FOUNTAIN WIND PROJECT

FINAL ENVIRONMENTAL IMPACT REPORT – VOLUME 2

Use Permit No. UP 16-007
State Clearinghouse No. 2019012029

Comment Letter P27

P27-50

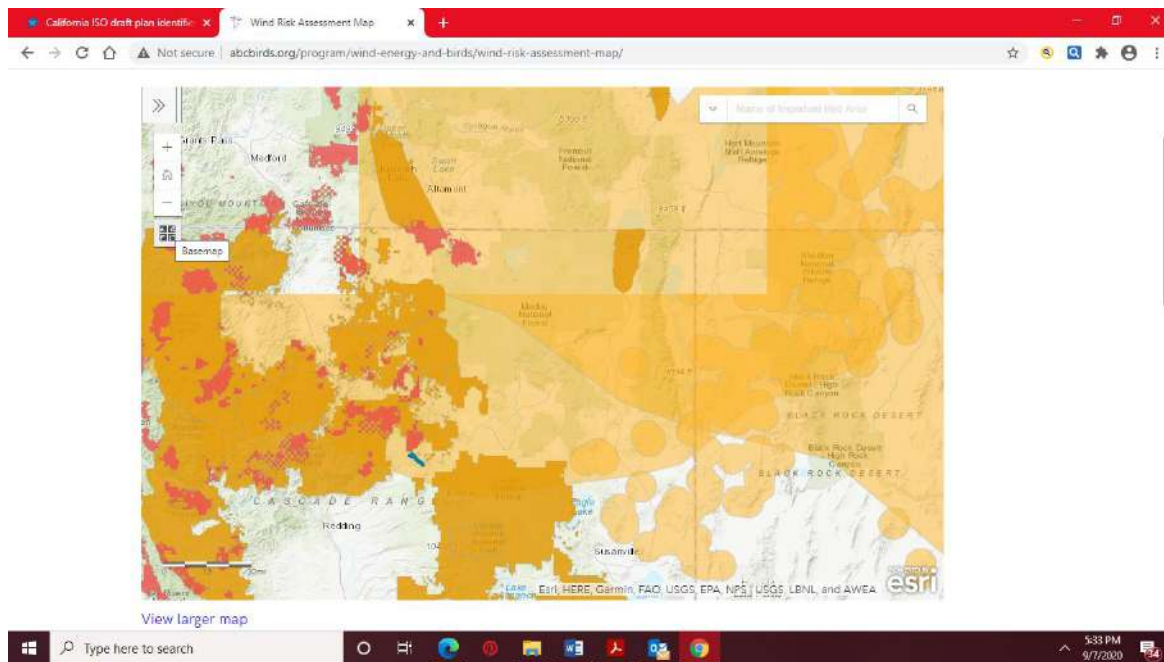
When residents attended the NOP meeting in January 2018 at the Montgomery Creek School we were presented with the overview of the Project by the County CEQA lead and an overview by the Consultant ESA. When we meet with the CEQA lead we were told that the County would take the lead in getting ESA on contract as the consultant, without any coordination from the Applicant, except to fund the work so they could avoid a conflict of interest (or even the perception).

In review of Appendix C, Biological Resources, the Site Characterization Study Report was completed and submitted to Pacific Wind in January 2017, by Western Ecosystems Technology, Inc. based on desktop analysis from 2011. The report was funded directly by Pacific Wind, LLC. The original request for the special use permit was submitted and signed by Shasta County on 7 November 2016, and the Biological Site Characterization Report is completed January 2017, just 8 weeks after the special use permit by Pacific Wind LLC, later to be changed to Fountain Wind LLC. The information from the initial report is from 2011 for another Project site specific to the McCloud Wind Resource Wind which was pointed out during the scoping comments regarding resource material for the wrong Project. The conflict of interest, or even the appearance of one, is apparent. The remainder of the Biological study, outside of the initial study completed in 2011, is merely addendums based on feedback from the CDFW and others during the scoping review period. The continual updates by the preparers of the biological studies further implies the conflict of interest is an attempt to play catch-up to include areas that would have been covered more effectively and with independent analysis had the Applicant taken the time and recommendations to include the Technical Advisory Committee(TAC) prior to announcing the Project. The TAC had been recommended during the scoping comments received in 2018 and 2019 which were never followed and as a result insufficient studies or analysis is seen in Appendix C.

P29-17

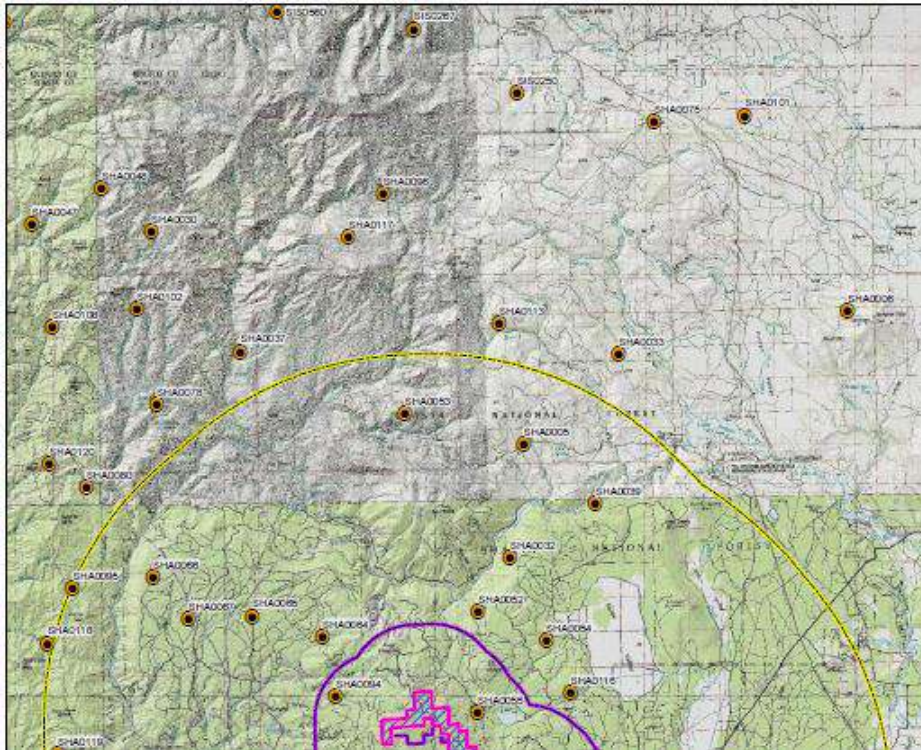
Besides the Fountain fire burning some of this owl habitat, what has happened to all these spotted owl nesting territories reported in the Hatchet Ridge EIR?

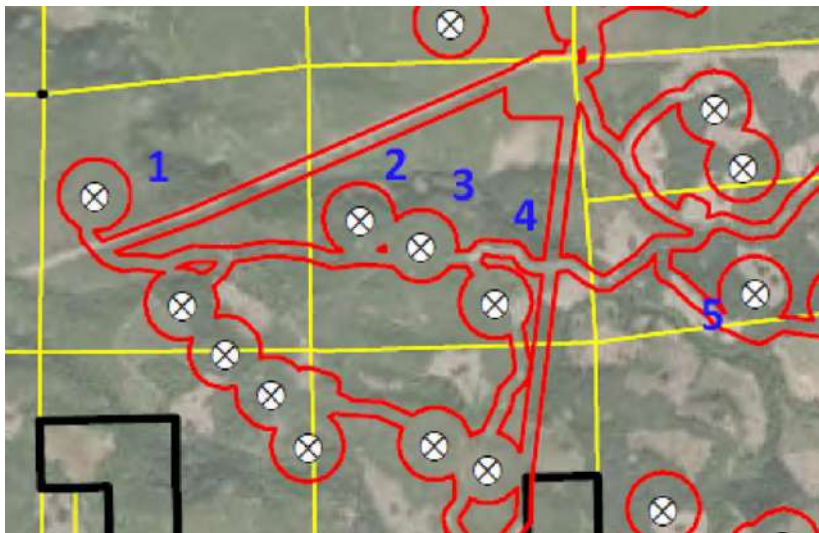
This element discusses conditions and issues relevant to the protection of public health and safety from fire damage. It also addresses sheriff protection in Shasta County. These topics are required under the State mandated safety element which reads:

Figure 7. Locations of raptor nests within two miles of Hatchet Ridge.

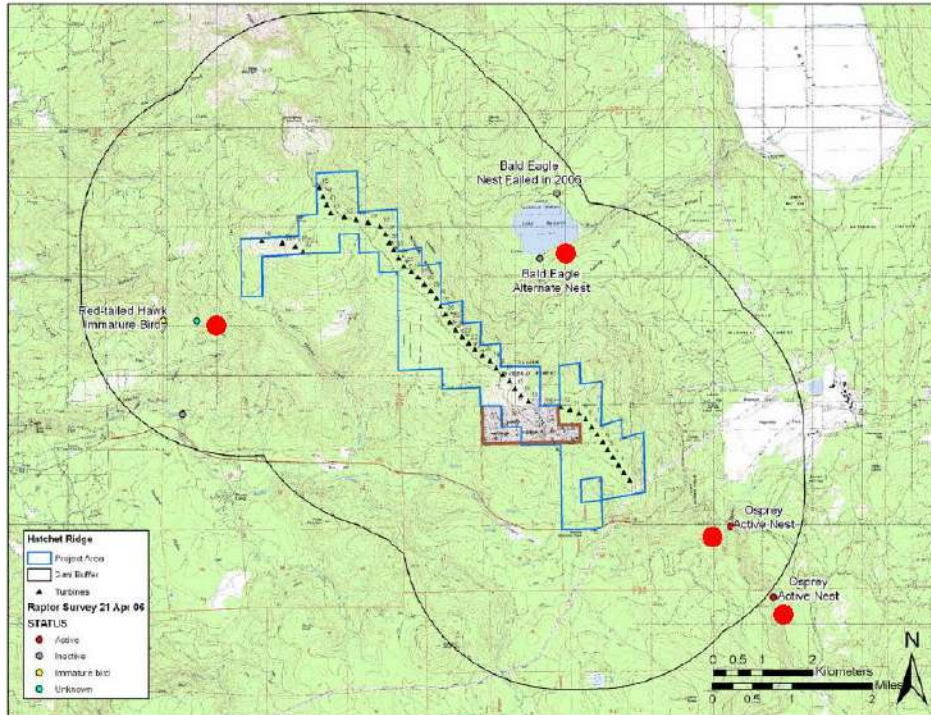
What has happened to these nesting territories since 2010 after 44 Hatchet ridge turbines became operational ???

Figure 3.4-1
Natural Vegetation Communities Found within the Project Site

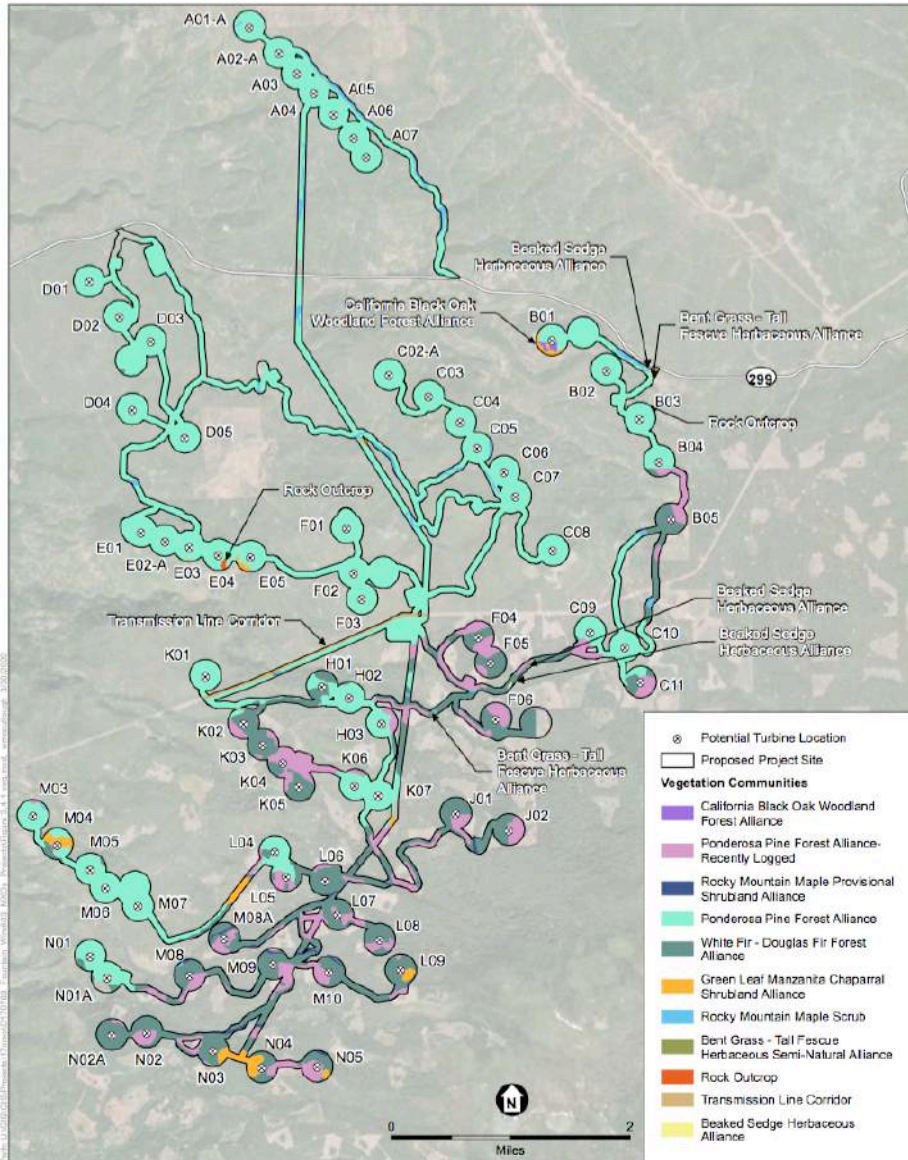
Figure 3.4-1, Natural Vegetation Communities Found within the Project Site presented on page 3.4-5 of the DEIR, and reproduced in Attachment 1 of this letter, only shows vegetation communities proximate to turbines and roads. It is ludicrous to assume that project impacts are limited to the *immediate* vicinity of the project infrastructure. The DEIR’s Project Overview (ES.2.1.) states: “The Fountain Wind Project is a renewable wind energy generation development proposed on approximately **4,464** acres in unincorporated Shasta County (Project Site),” whereas page 1 of the Executive Summary of Appendix C, Biological Resources, states: “The proposed Project encompasses approximately **32,600** acres (50.9 square miles) of private land in central Shasta County.” By confining the analysis to 4,464 acres rather than 32,600 acres, many of the project impacts are not properly assessed. The removal of habitat to accommodate project infrastructure will impact habitat connectivity over an area greater than 4,464 acres.

Attachment 2

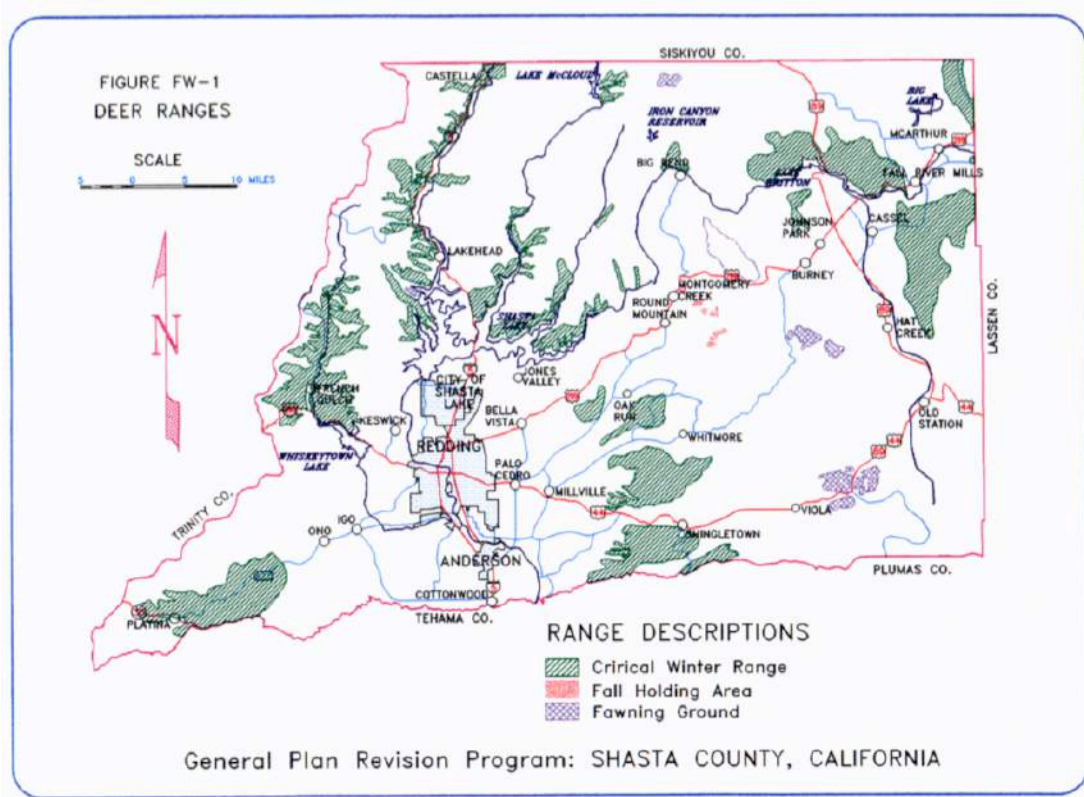
The map in Attachment 2 of this letter, Figure FW-1, *Deer Ranges*, shows much of the project site is a *fall holding area* for deer. If the project were to go forward, the environmental analysis and associated mitigation approach would need to address the requirements discussed in the Joint Hardwood Policy. The DEIR has a number of discussions of deer populations, with discussion of possible interactions with project infrastructure. It needs to also include analysis of proposed project impacts on hardwoods with consideration for deer populations given that the habitat fragmentation impacts extend from the roadways, turbine towers, and other associated infrastructure. Any other hardwood impacts in the 32,600-acre footprint of the project should also be assessed, and mitigation—the DEIR currently has no mitigation for hardwood impacts—should also be calculated based on the project’s full impacts.

The County acknowledges receipt of this copy of Figure FW-1, *Deer Ranges*, from the County's General Plan. The Draft EIR (at pages 3.4-15, 3.4-27, 3.4-67, 3.6-2, 3.6-16) discloses and considers that the Project Site has suitable habitat for deer fawning and that mammals found in mixed conifer forest include deer. In any conflict among the protection of habitat resources and the timber land use classification, General Plan Policy FW-b instructs that the timber land use classification "shall prevail in a manner consistent with State and Federal laws."⁷⁸

Possible slide seen near Turbine B4 (left picture 2005/ right 2016)

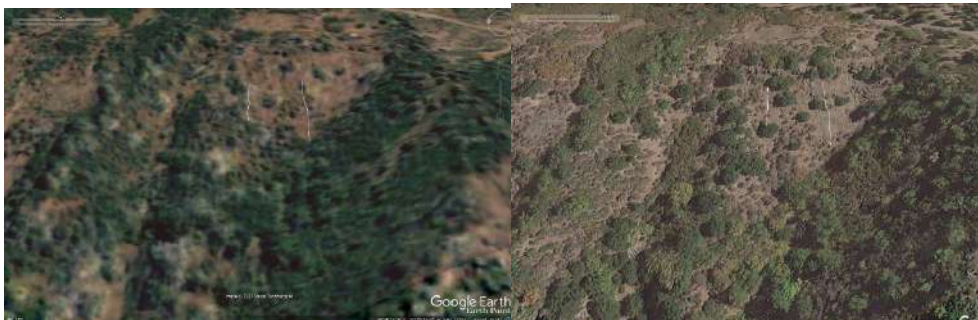
This simply shows that impact 3.9-3 simply is incorrect and possibly intentionally hidden. With the evidence provided they cannot state that the adverse effects directly or indirectly is “less than significant.” Considering the entire area is composed of similar soil and geology. It is insulting particular to those living in the area that know these slides happens and that the report continues to say though no evidence is found a “required-site specific, design-

The comment references a specific location at turbine "I5." However, there is no such turbine location with this attribution as shown in Draft EIR Figure 2-2. Regardless, as stated above, the analysis of landslides hazards in Section 3.9 assumes that landslide hazards are likely present at the site. As discussed on page 3.9-16, all proposed improvements, as required by law, would be subject to applicable provisions of the California Building Code (CBC). As stated on page 3.9-10 of the Draft EIR [**bold text added for emphasis**]:
